Proposed Development at 88 Walker Street  
Response to Traffic Submissions to Public  
Exhibition

23 Sept 2009  
Final

Prepared for  
**Eastmark Holdings Pty Ltd**

# BERRY STREET/WALKER STREET TRAFFIC VOLUMES

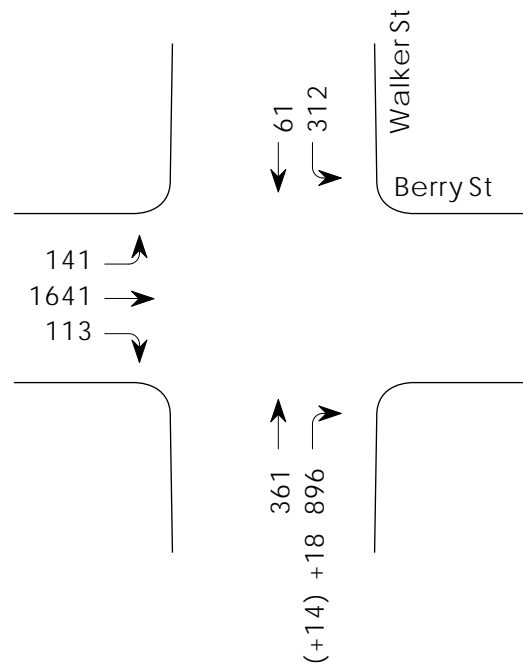
This is related to the first point. To illustrate the minimal effect that the proposed developments would have on this intersection we provide on Figure 1 in Appendix B the following traffic figures for morning and evening peak hours at this intersection.

- Existing peak hour turning movements;
- Additional traffic determined in our original traffic analysis
- Additional traffic for 88 Walker Street and 100 Mount Street combined as determined in Chapter 2.

From this it will be seen that:

- The two developments would increase total movements through the intersection by 0.4% in the morning peak and 0.5% in the evening peak.
- The extra traffic would turn right into Berry Street from the south and the increase on this movement would only be 1.5% in the morning peak and 2.0% in the evening peak.

These volume increases are very low and would be indistinguishable from day to day variation at the intersection.

# MINI BUSES USING THE LOADING DOCK

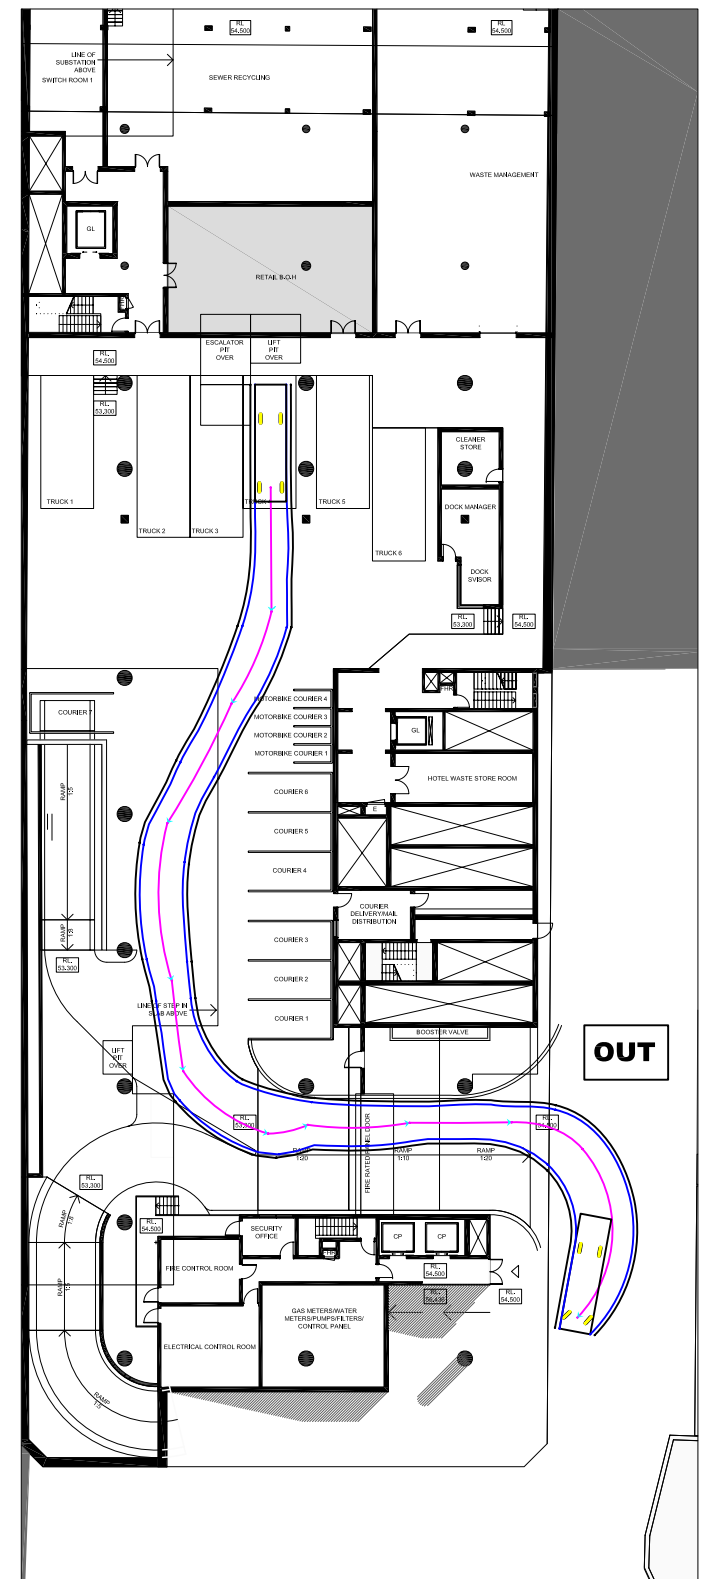
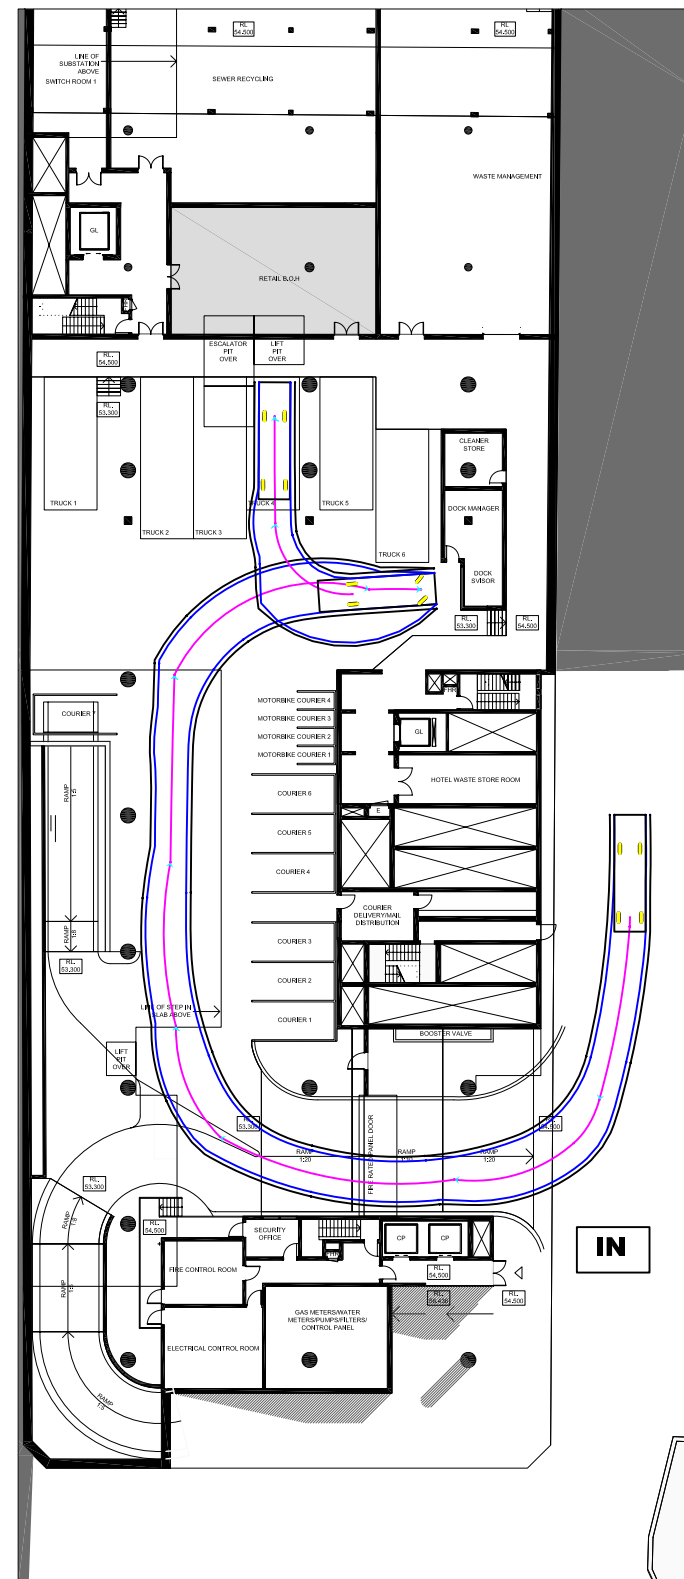
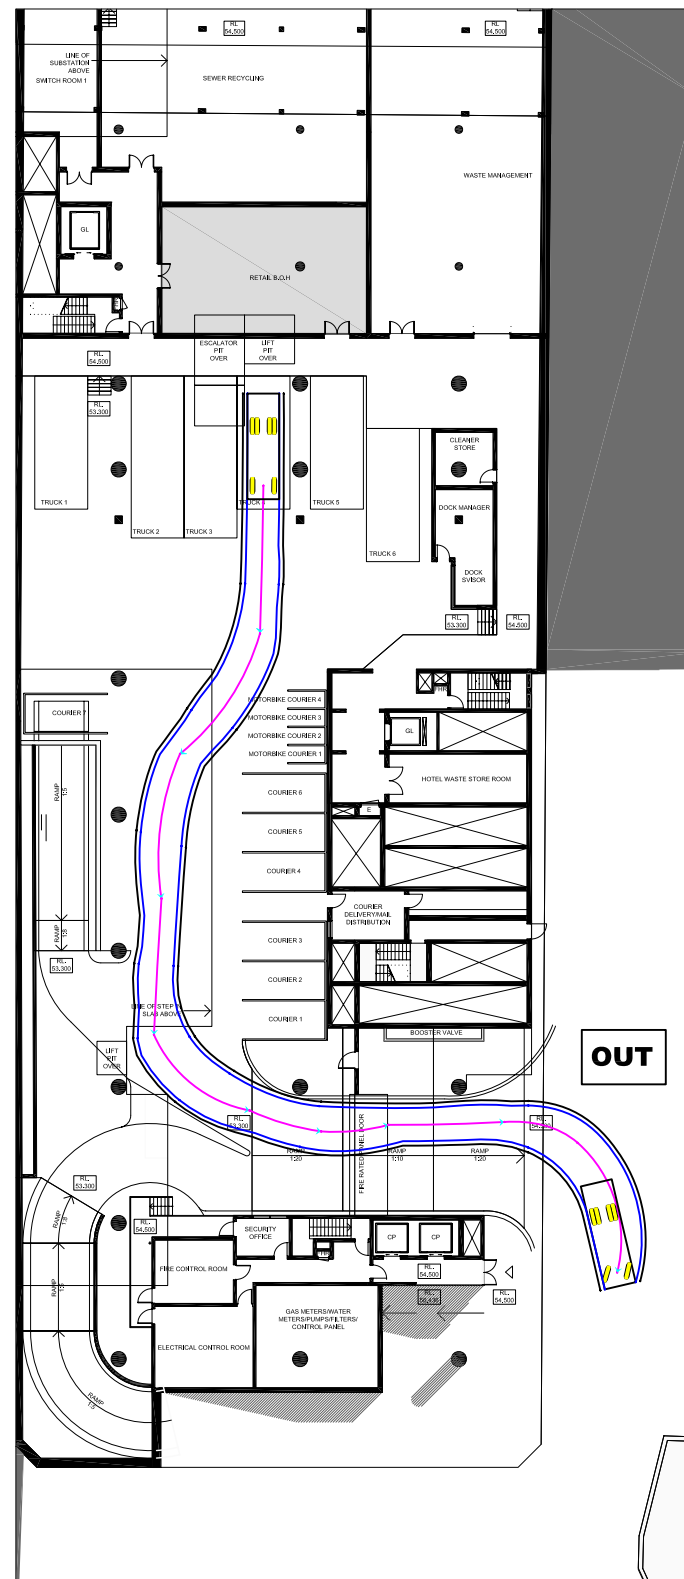
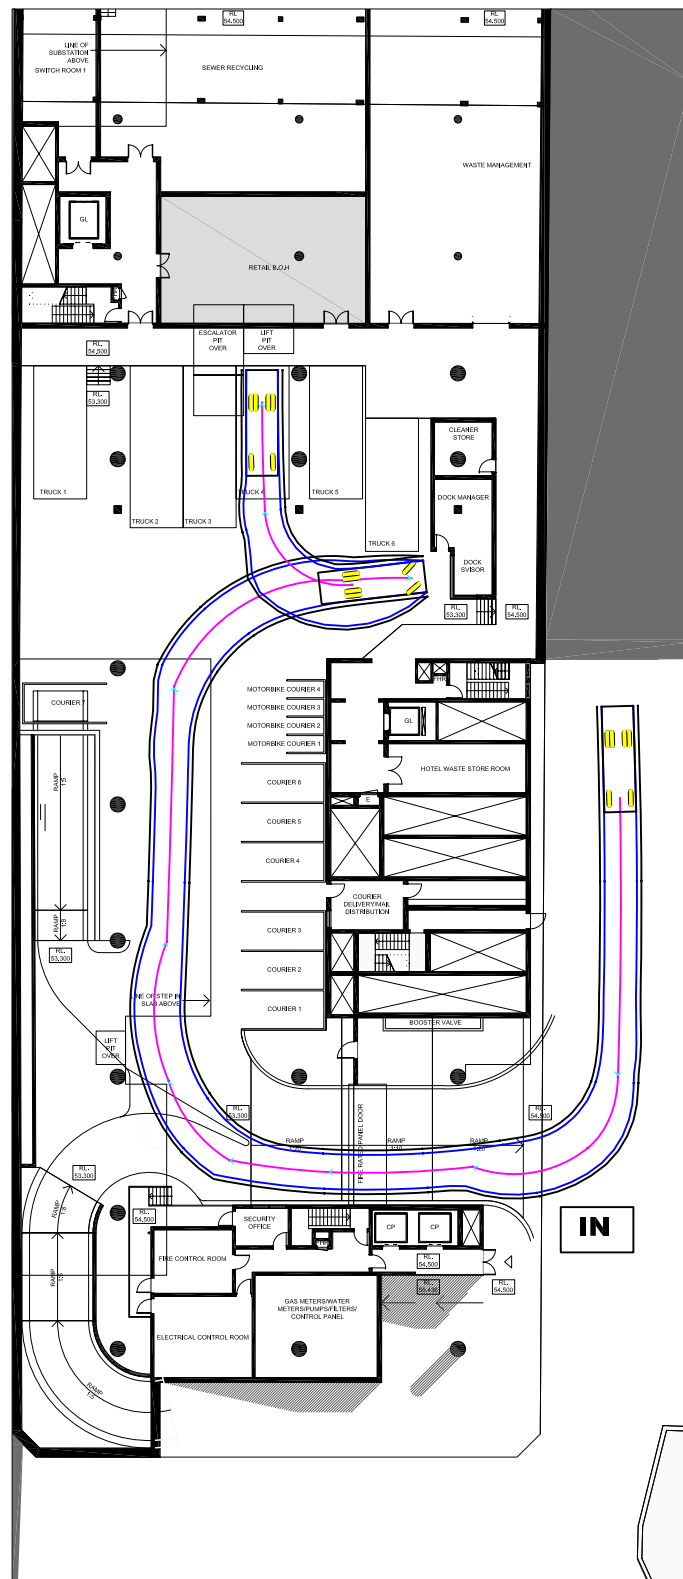
A proposed pick up/drop off zone that could be used by hotels is proposed in Little Spring Street. In addition 25 seater buses would be able to use the loading area. Use of this area by buses will be allowed for as part of a loading area management plan.

Notwithstanding this, the proposed drop off/pick up zone would be able to accommodate buses with up to 30 seats. In addition a 25 seater bus would be able to use the loading area. It is proposed that the management plan for the loading area provide for incidented use by such.

# 10.7m HRV USING THE LOADING BAY

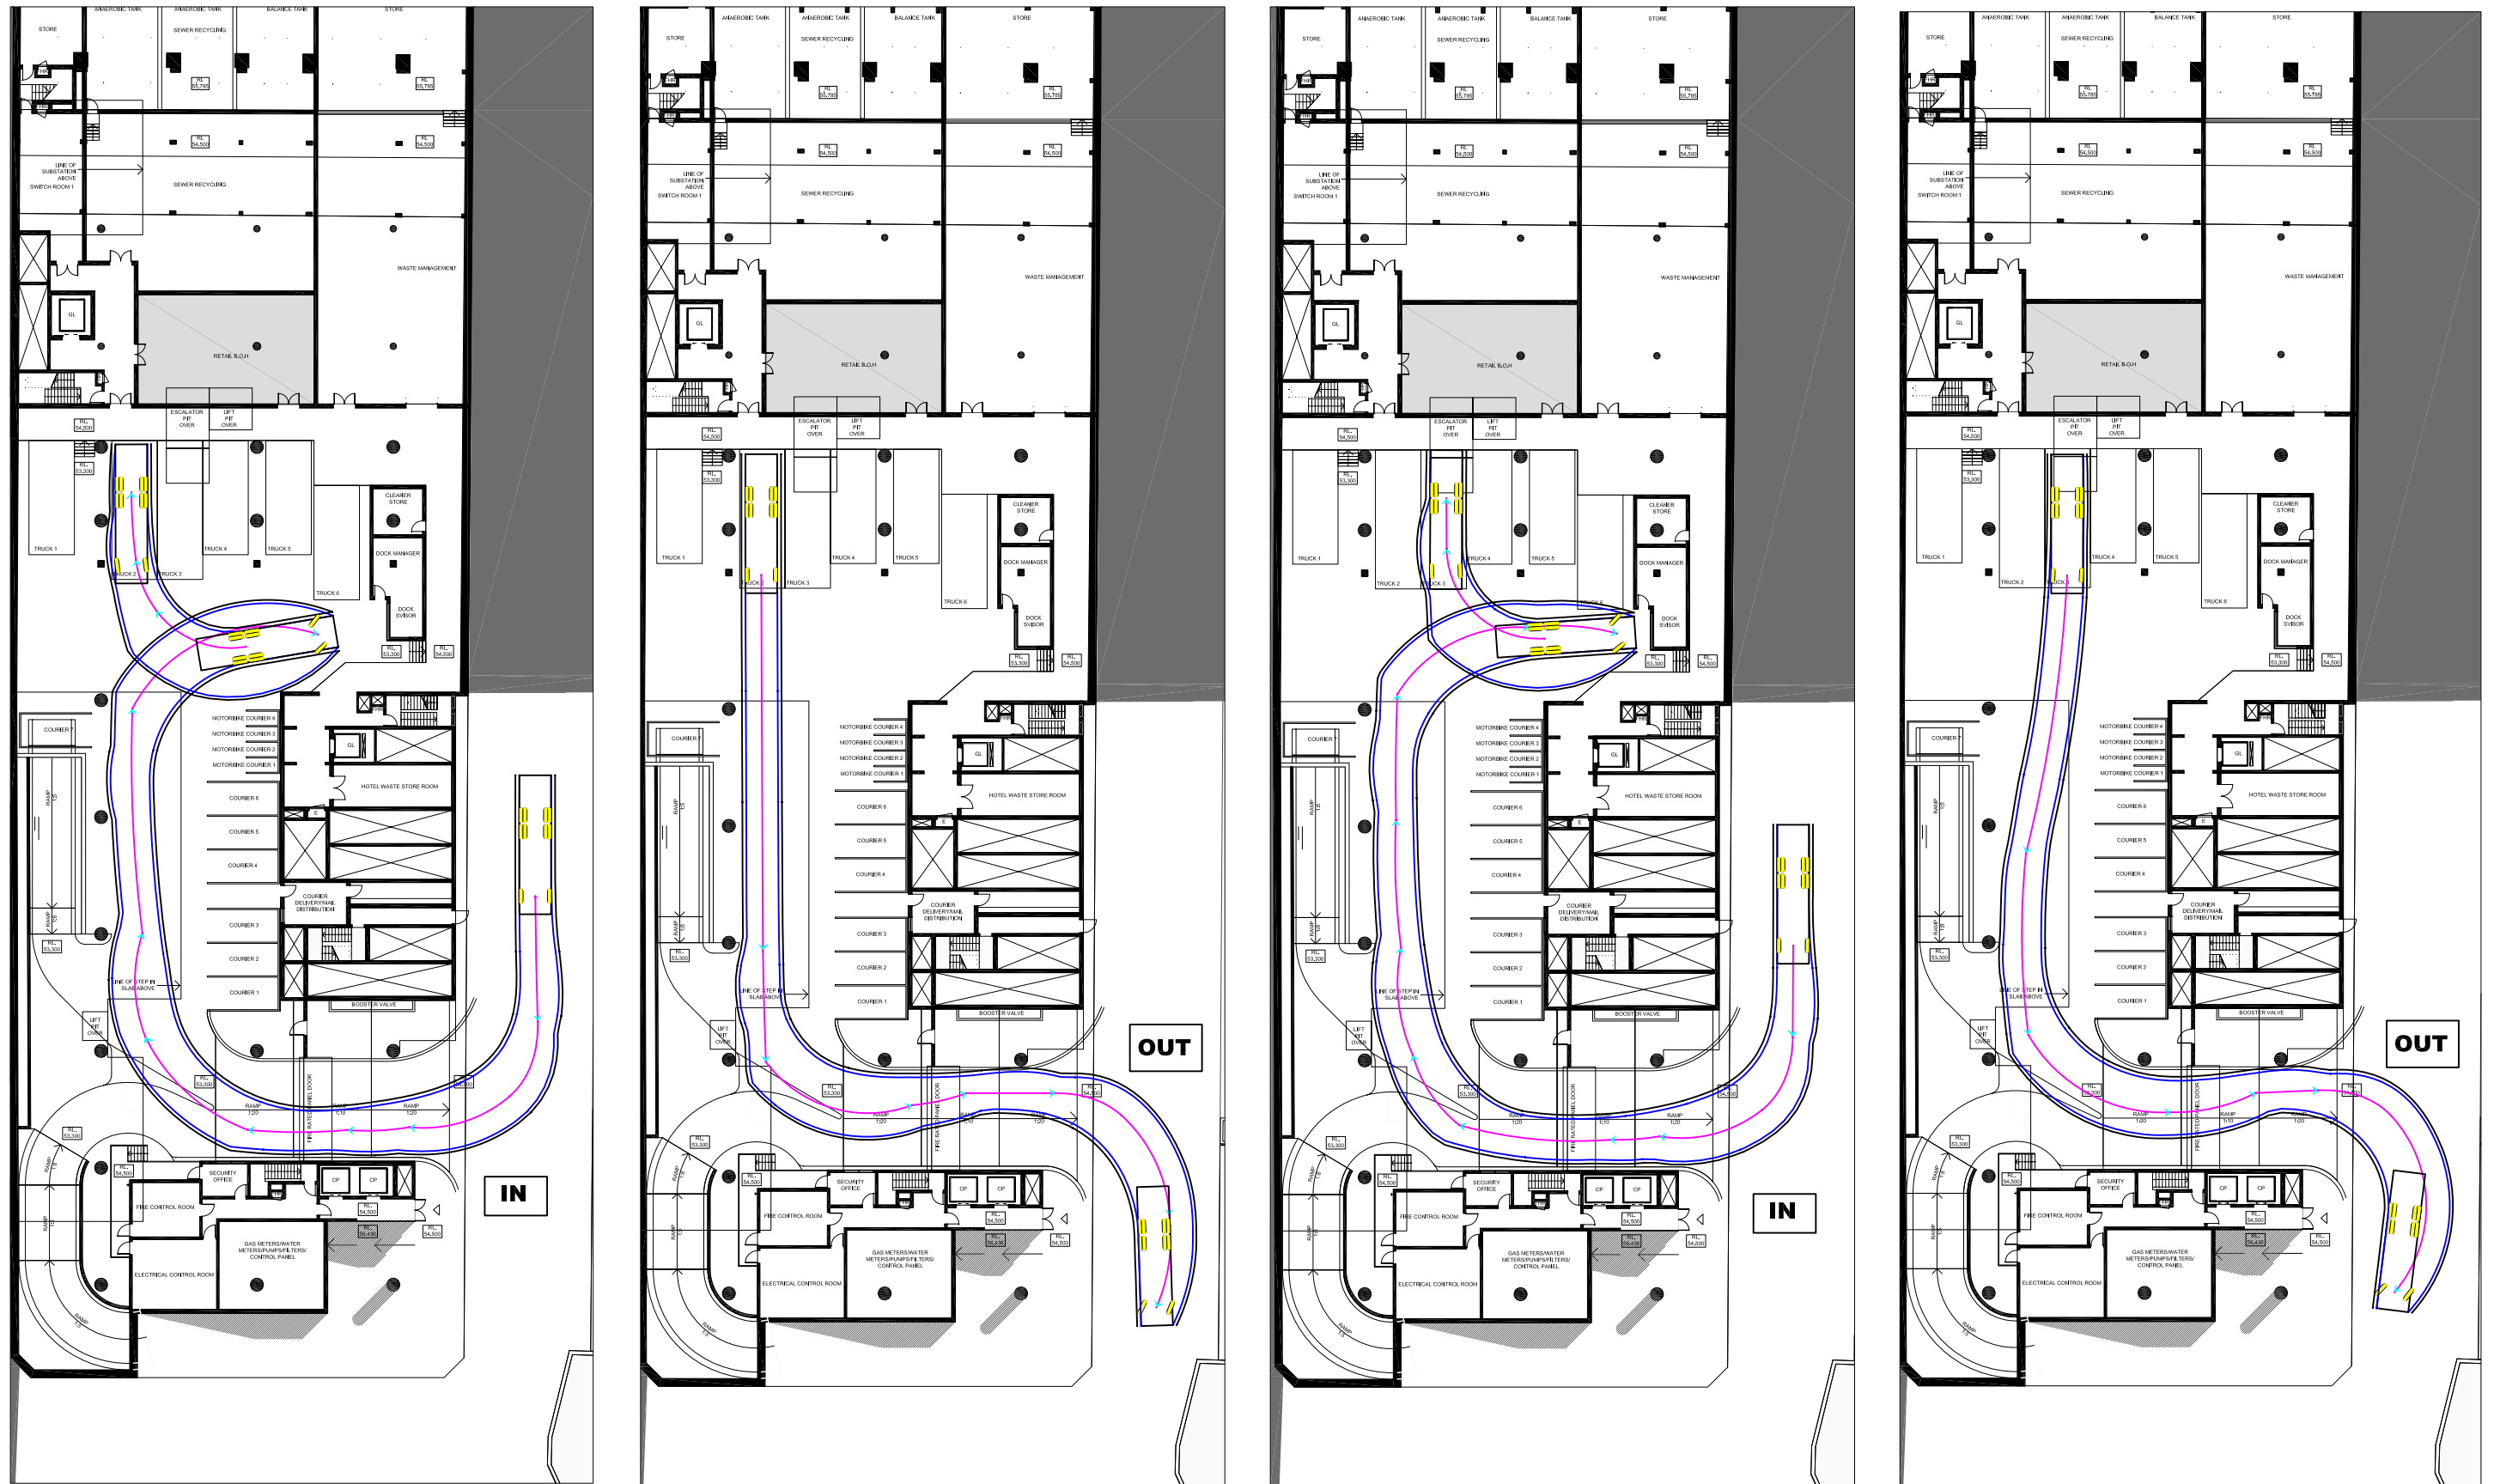
#### Internal Design Service Area

Swept path diagrams are provided as an appendix to this submission.

Vehicle turning path diagrams drawn using the widely use Autoturn Computer Program as provided in Appendix C.

These demonstrate the workability of the loading area and that trucks will be able to enter and exit in a forward direction.
